Device TC1724F/N, TC1728F/N
Marking/Step ES-AC, AC
Package see Data Sheet

02807AERRA

This Errata Sheet describes the deviations from the current user documentation.

Figure 1 Timing concerning equidistant multiple timers

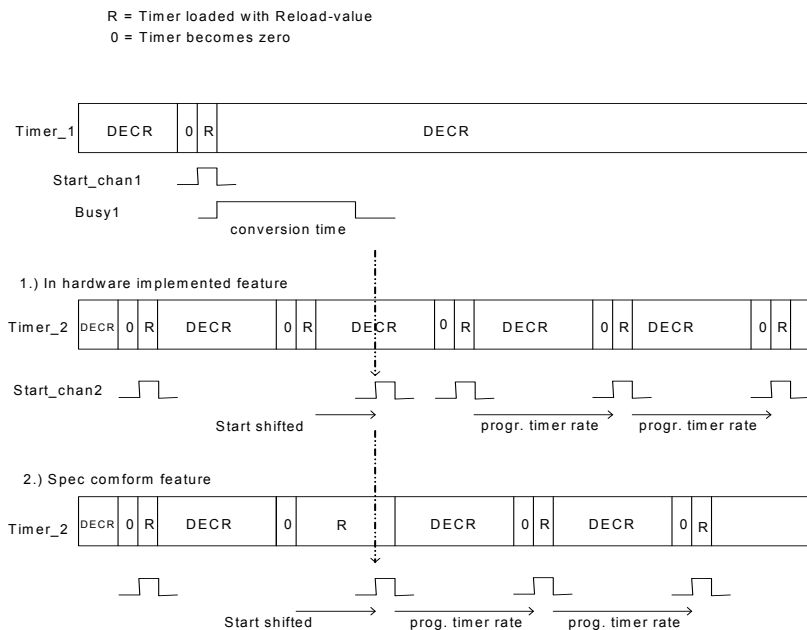
FADC_TC.005 Equidistant multiple channel-timers

The description is an example for `timer_1` and `timer_2`, but can also affect all other combinations of timers.

`Timer_1` and `Timer_2` are running with different reload-values. Both timers should start conversions with the requirement of equidistant timing.

Problem description:

`Timer_1` becomes zero and starts a conversion. `Timer_2` becomes zero during this conversion is running and sets the conversion-request-bit of `channel_2`. At the end of the conversion for `channel_1` this request initiates a start for `channel_2`. But the `Timer_2` is reloaded only when setting the request-bit for `channel_2` and is decremented during the conversion of `channel_1`.

The correct behavior would be a reload when the requested conversion (of `channel_2`) is started.

Therefore the start of conversion for `channel_2` is delayed by maximum one conversion-time. After this delay it will be continued with equidistant conversion-starts. Please refer to the following figure.

Note: the programmed timer rate is much longer than the conversion time, this means that the fault is much smaller than in the picture

Use one timer base in combination with neighboring trigger and selection by software which result has to be taken into account.

Figure 2 Alert Interrupt Behavior in case of Bus-Off

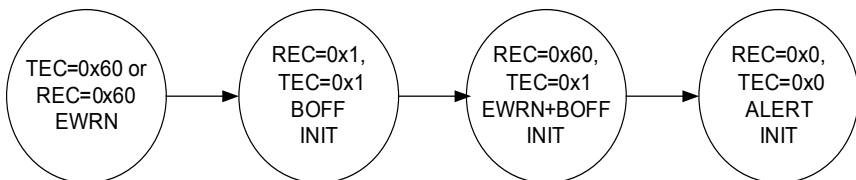
MultiCAN_AI.H007 Alert Interrupt Behavior in case of Bus-Off

The MultiCAN module shows the following behavior in case of a bus-off status:

When the threshold for error warning (EWRN) is reached (default value of Error Warning Level EWRN = 0x60), then the EWRN interrupt is issued. The bus-off (BOFF) status is reached if TEC > 255 according to CAN specification, changing the MultiCAN module with REC and TEC to the same value 0x1, setting the INIT bit to 1_B, and issuing the BOFF interrupt. The bus-off recovery phase starts automatically. Every time an idle time is seen, REC is incremented. If REC = 0x60, a combined status EWRN+BOFF is reached. The corresponding interrupt can also be seen as a pre-warning interrupt, that the bus-off recovery

Figure 3 Loss of Arbitration

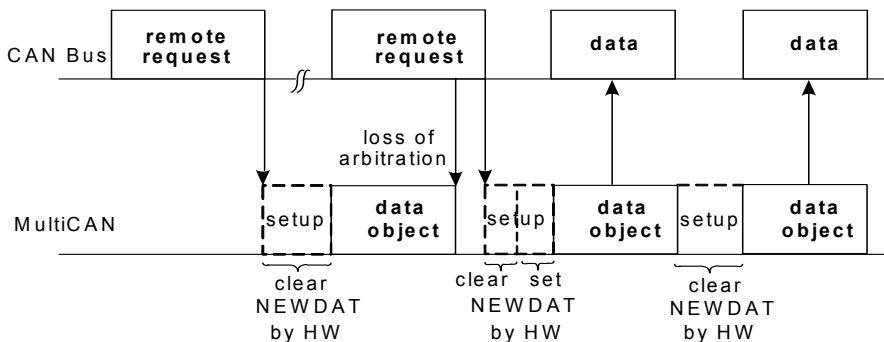
When the appropriate message object (data frame) triggered by the first remote frame wins the arbitration, it will be sent out and NEWDAT is not reset. This leads to an additional data frame, that will be sent by this message object (clearing NEWDAT).

There will, however, not be more data frames than there are corresponding remote requests.

Figure 4 **PORST Redundancy Path**

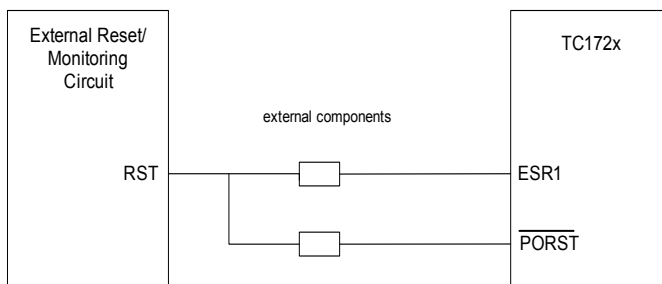
The $\overline{\text{PORST}}$ pad includes a strong pull-down device controlled by the EVRs. This allows pin $\overline{\text{PORST}}$ to be actively driven low upon a threshold violation of (at least one of) the monitored supply voltages. For the characteristics of this pull-down see parameter $\overline{\text{PORST}}$ pad output current I_{DDPORST} in the Data Sheet.

Besides this (switchable) pull-down, the $\overline{\text{PORST}}$ pad has a permanent internal weak pull-up (see parameter Pull-Up current I_{PUH} in Data Sheet).

Recommendation:

a) Connect the reset line additionally to the ESR1 pin (or other appropriate pins) to provide a redundant path to detect such a failure mode.

b) Activate internal voltage monitoring for external supply which acts as a redundant supply watchdog in addition to the supply monitoring carried out by the external regulator.
